**RE: Construction Permit Application for a Proposed Utility Waste Landfill, Ameren Missouri
Labadie Energy Center, Franklin County, Missouri, Response to Comment Letter dated May 7,
2013**

Construction Permit Application
Proposed Utility Waste Landfill
Ameren Missouri Labadie Energy Center
Franklin County Missouri

Response to MDNR-SWMP Review Comments

LABADIE ENERGY CENTER
PROPOSED UTILITY WASTE LANDFILL
OVERALL BOTTOM GRADING PLAN (TOP
OF LINER)

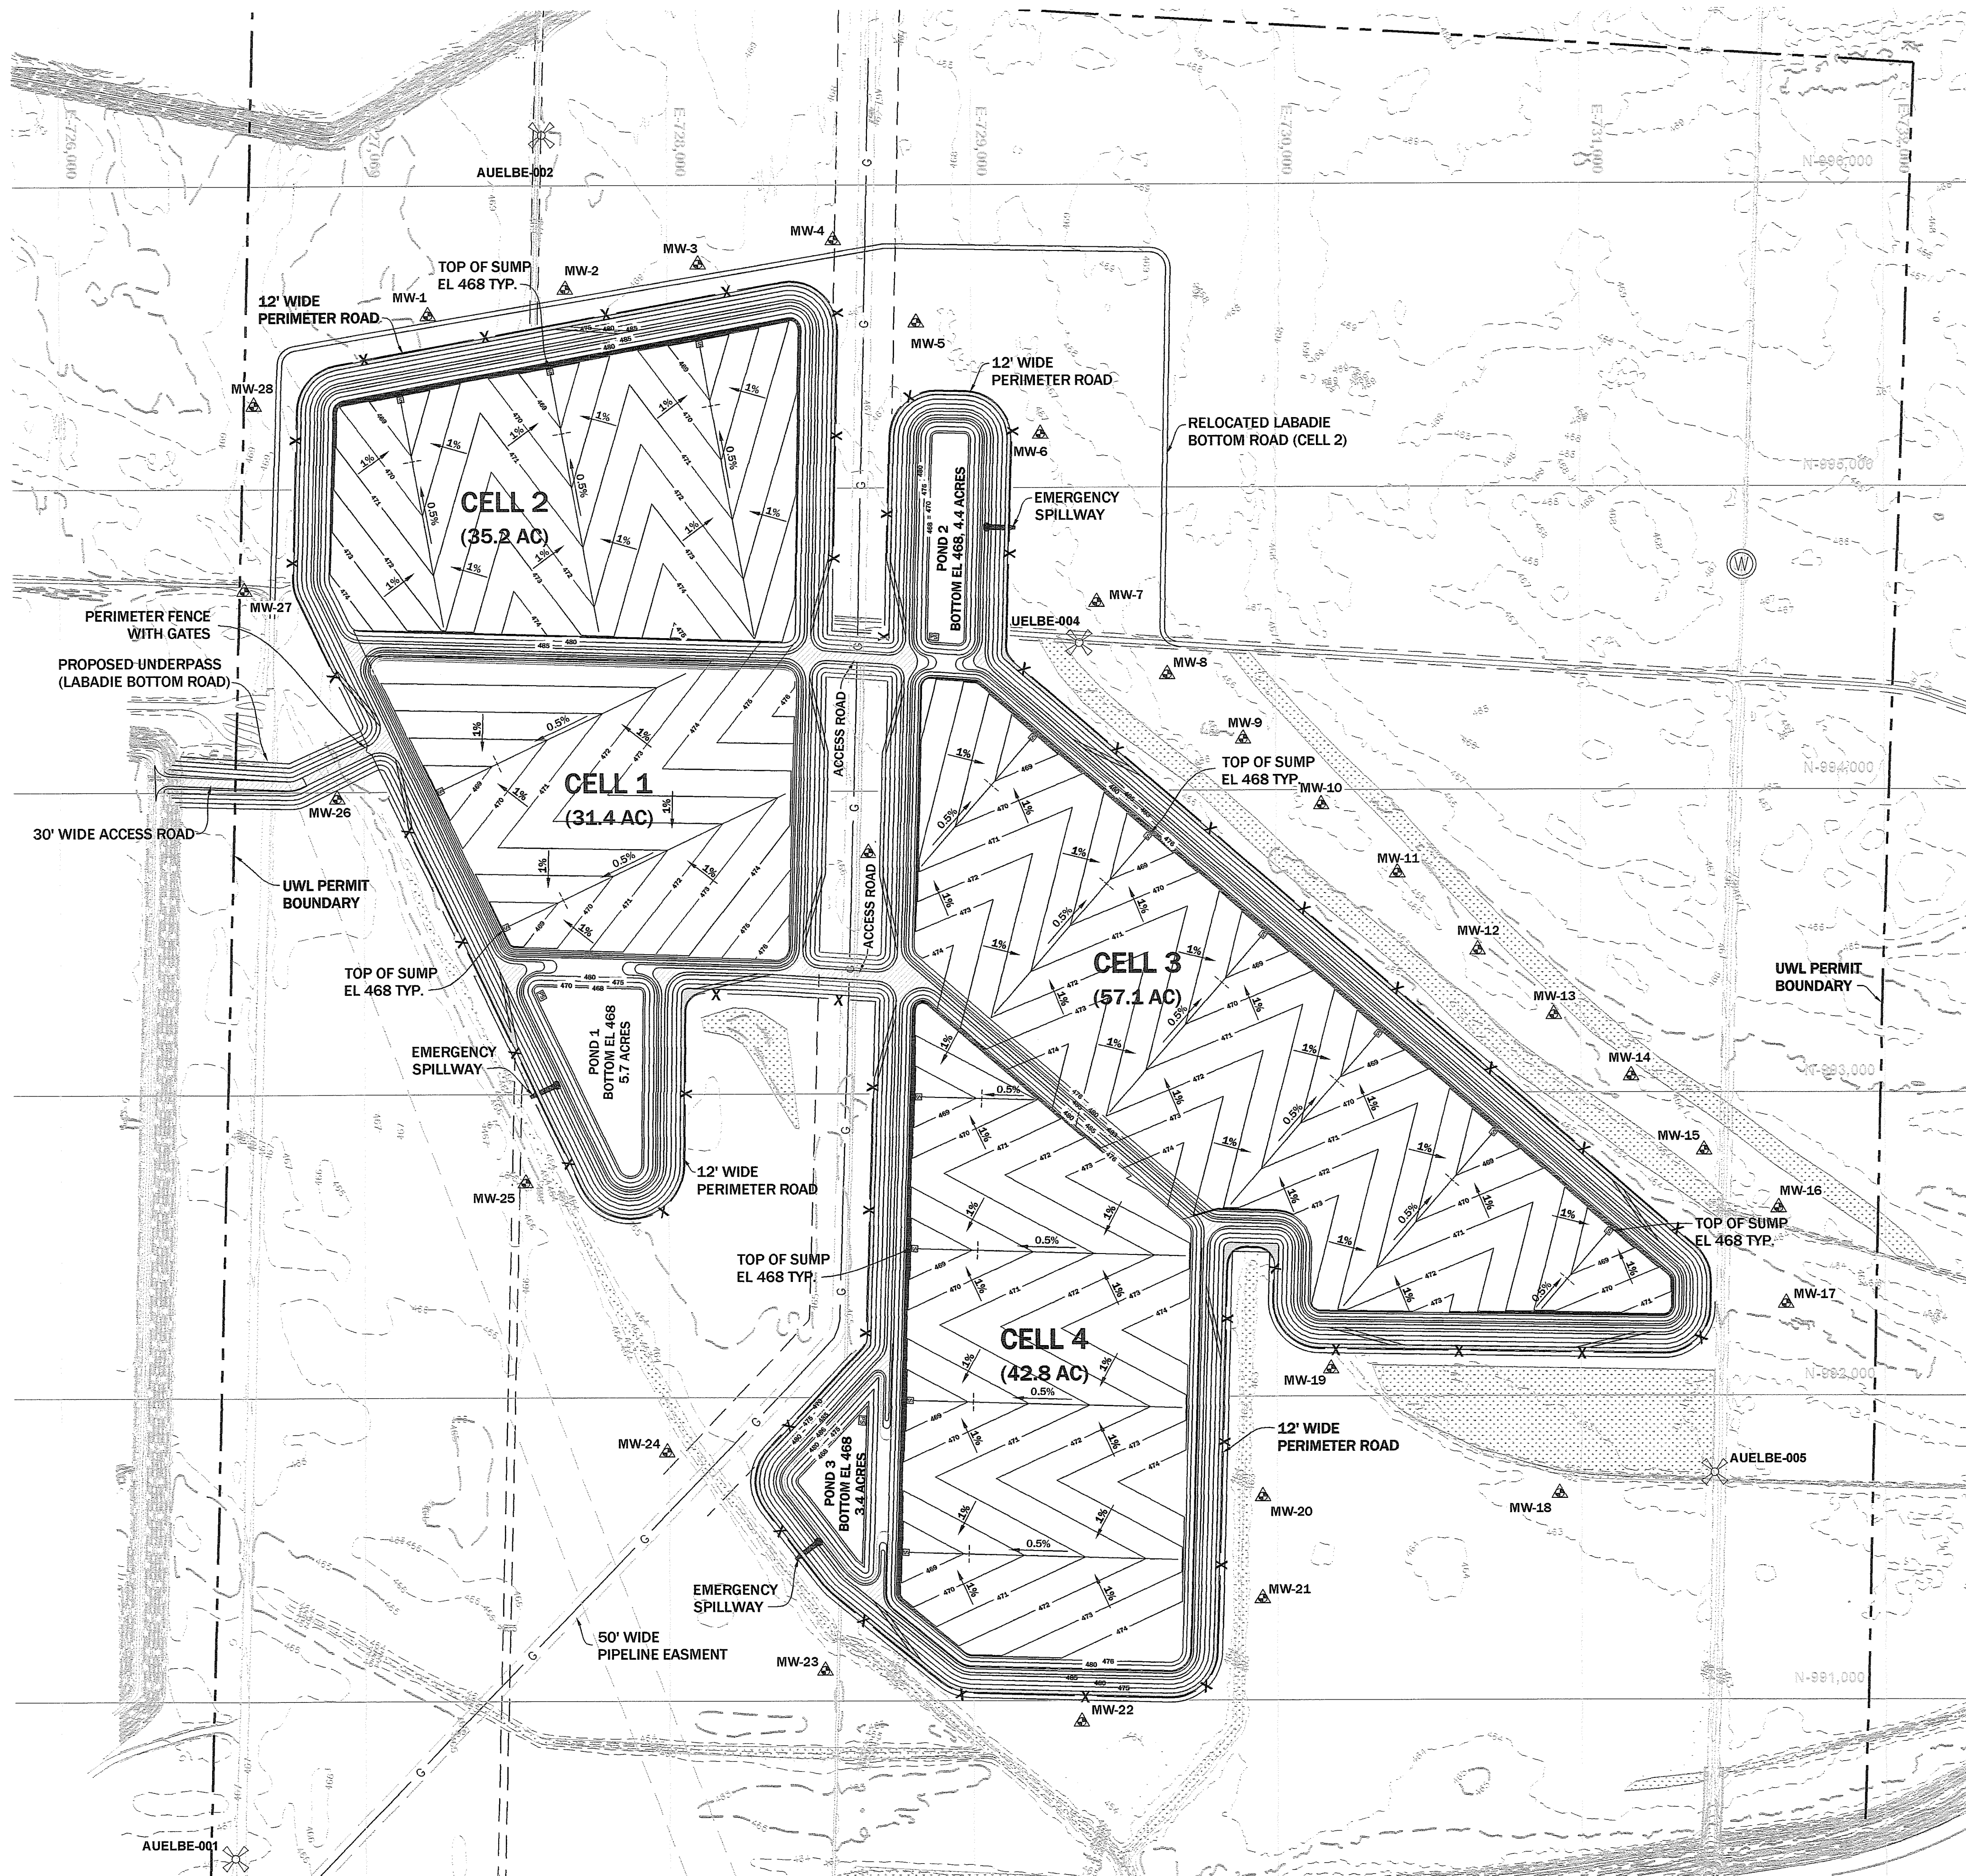
MDNR 6 Per 10 CSR 80-11.010(4)(B)2.A., please show the setbacks to wetland areas and other buffers on Sheet 3. **Response:** Sheets 3, 5, 10 and 19 have been revised to identify a minimum 25 foot buffer between the limits of disturbance and jurisdictional wetland areas. A note has also been added to Sheet 3 regarding the limited activities allowed north of the Ineffective Flow Boundary (i.e. no fill may be placed north of the Ineffective Flow Boundary).

MDNR 9 Please depict the limits of Fabri-Form installation along all berms on all sheets that illustrate the location of the material. **Response:** Sheets 6 through 9 and 11 through 14 have been revised to show the installation of FCM on all exterior berms. Because of the large scale of Sheets 5 and 10 a note was added to each sheet to address this comment.

- CELLS 1 & 3 AREAS WERE MEASURED TO INSIDE TOP OF EXTERIOR BERMS AND OUTSIDE TOE OF INTERIOR BERMS.
- CELLS 2 & 4 AREAS WERE MEASURED TO INSIDE TOP OF EXTERIOR BERMS AND INSIDE TOE OF INTERIOR BERMS.
- POND AREAS WERE MEASURED FROM THE INSIDE TOP OF BERM.
- FABRIC-FORMED FILTER-POINT CONCRETE MAT (FCM) ON NON-WOVEN GEOTEXTILE FILTER TO BE PLACED ON THE OUTSIDE FACE OF ALL EXTERIOR BERMS.
- ALL LAND DISTURBANCE ACTIVITIES WILL HAVE A 25' MINIMUM SETBACK FROM JURISDICTIONAL WETLANDS WITH A STORMWATER BMP INSTALLED BETWEEN THE DISTURBANCE AND THE WETLAND DURING CONSTRUCTION. SEE DETAIL 4 ON SHEET 13.

SHEET 7
PROPOSED UTILITY WASTE LANDFILL
CELL 2 GRADING PLAN (TOP OF LINER)

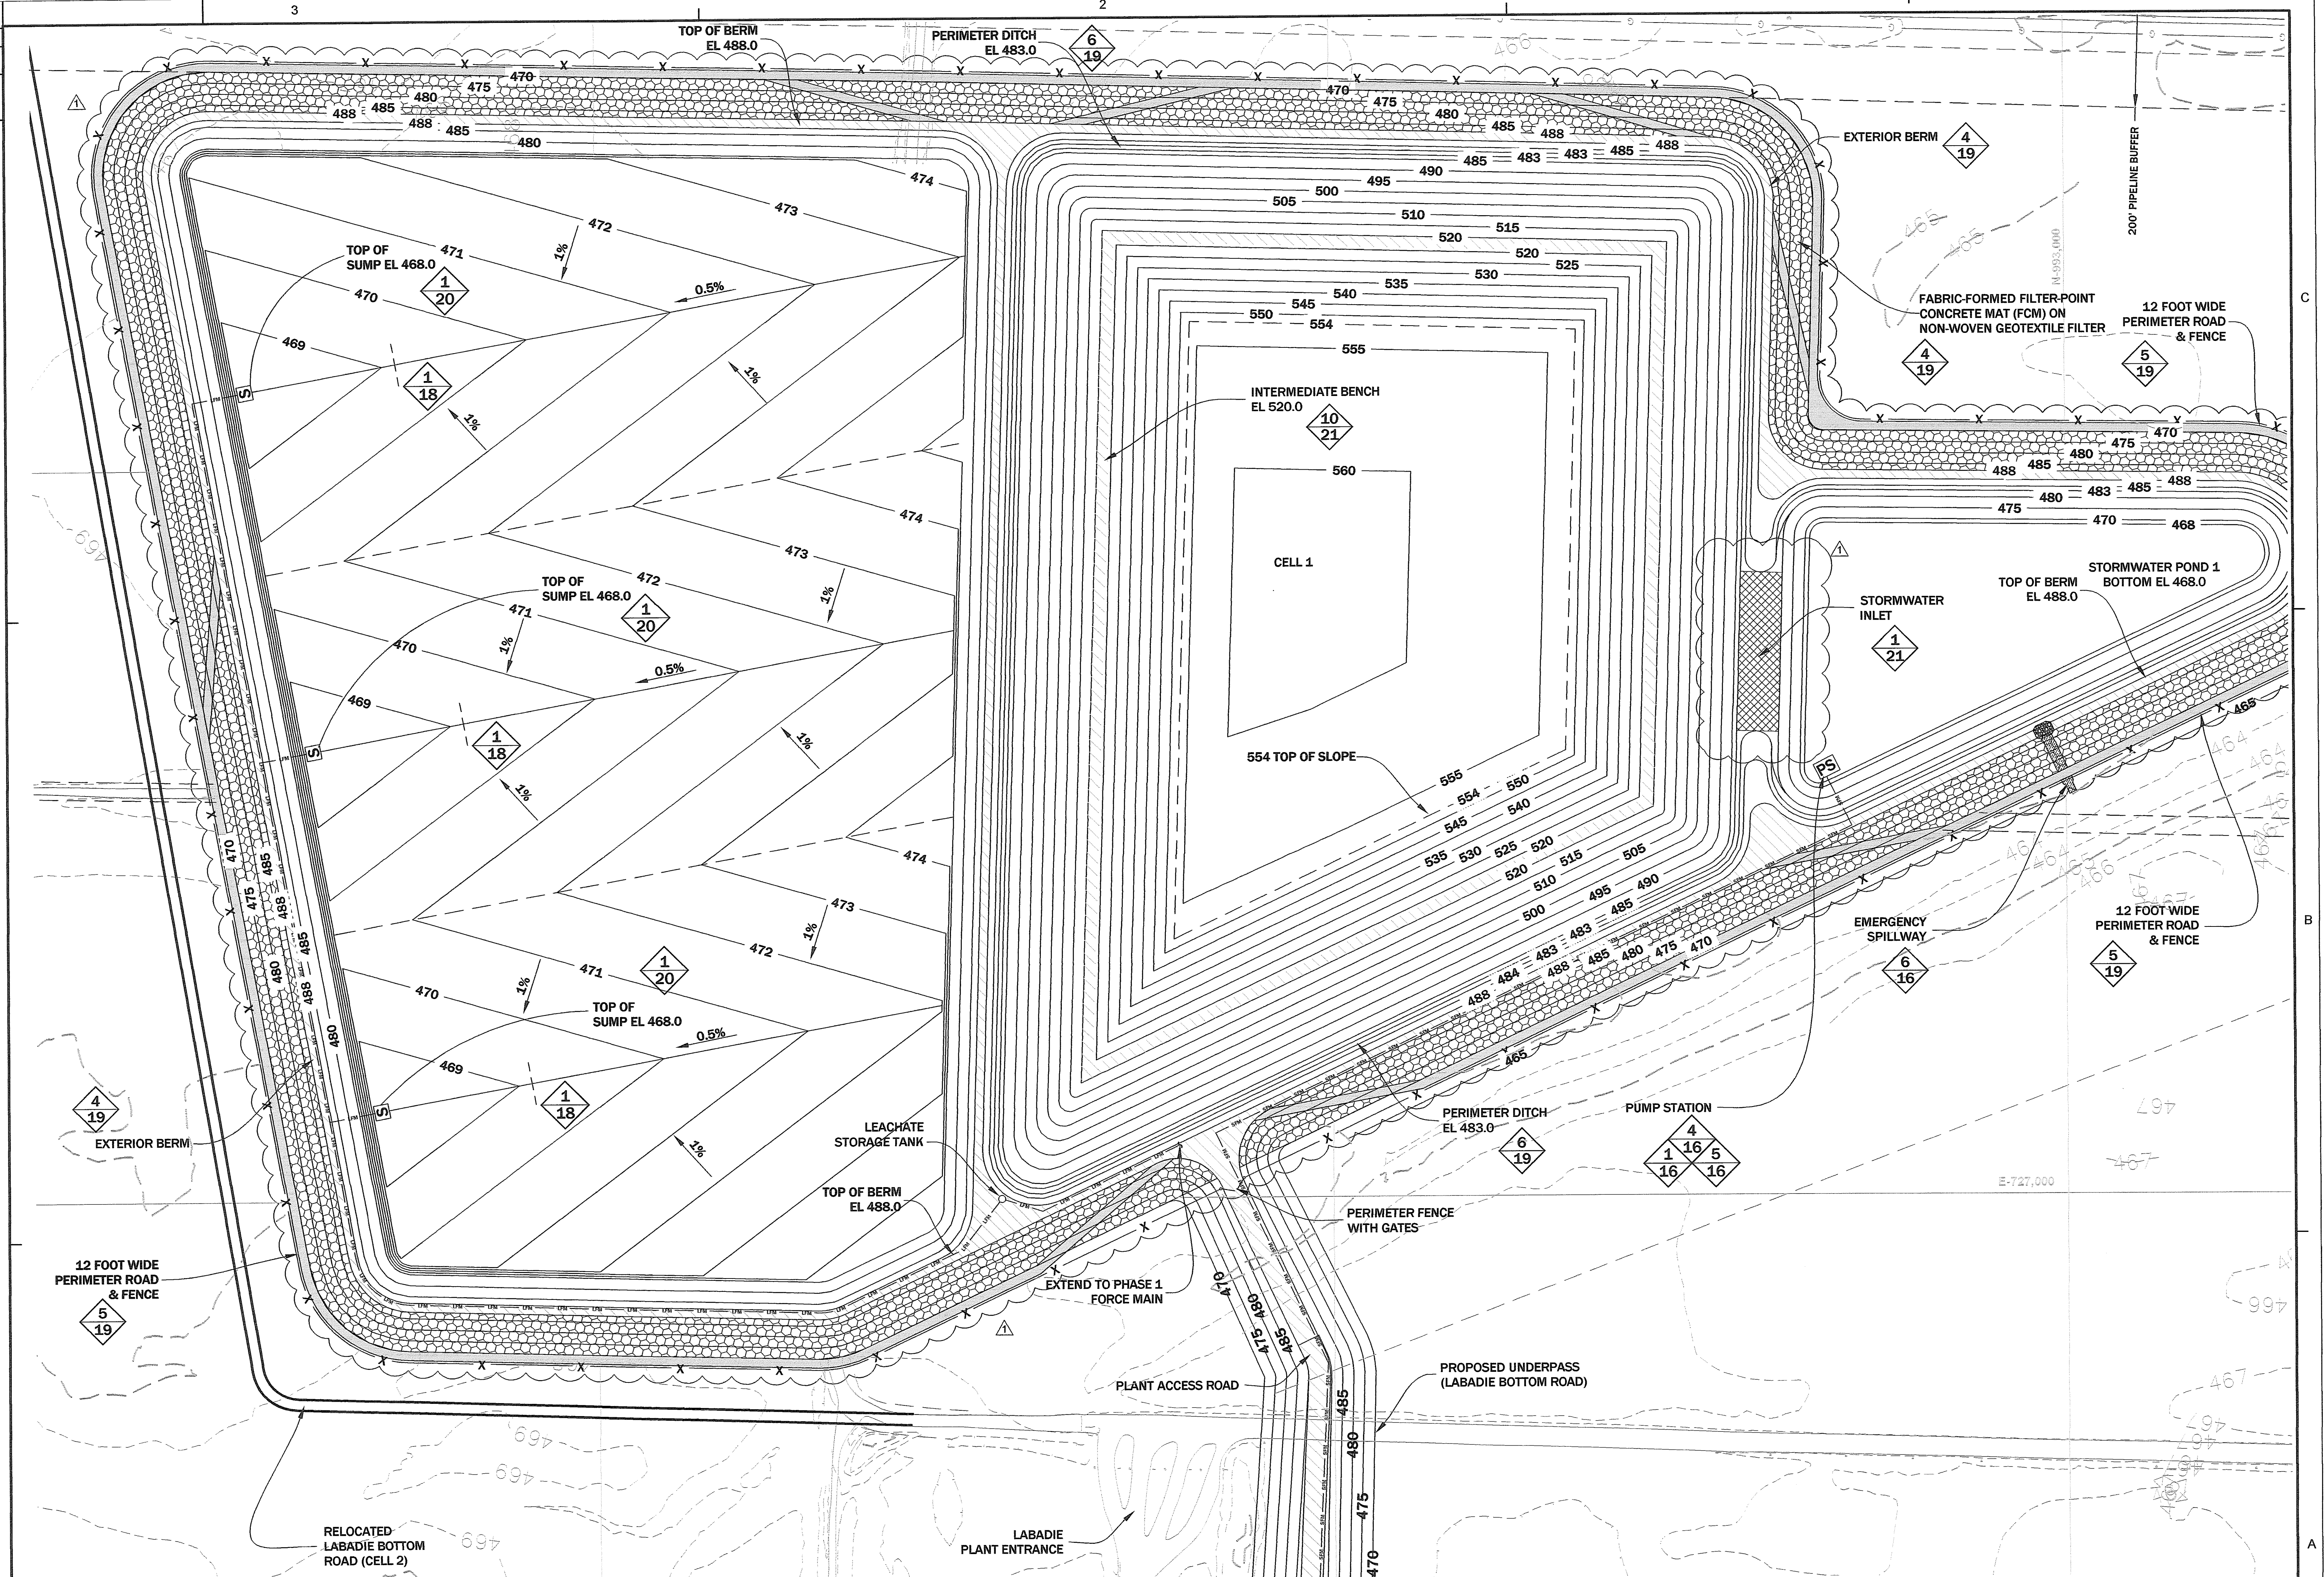
MDNR 8 Remove Note 2 from Sheets 6-9 and 11-14. **Response:** Note 2 has been removed from revised plan Sheets 6 through 9 and 11 through 14, and the notes on each Sheet have been renumbered as appropriate.

MDNR 10 Indicate, through hatching or another method, the stormwater entity along the east berm between the waste cell and basin on Sheet 7. **Response:** Sheets 6 through 9 and 11 through 14 have been revised to identify the stormwater inlets (the stormwater entities) between the appropriate cells and stormwater ponds.

08/02/13: ADD FABRIC FORMED TO OUTSIDE TOP OF BERM. ADD HATCH TO STORMWATER INLET. REMOVE NOTE (2).
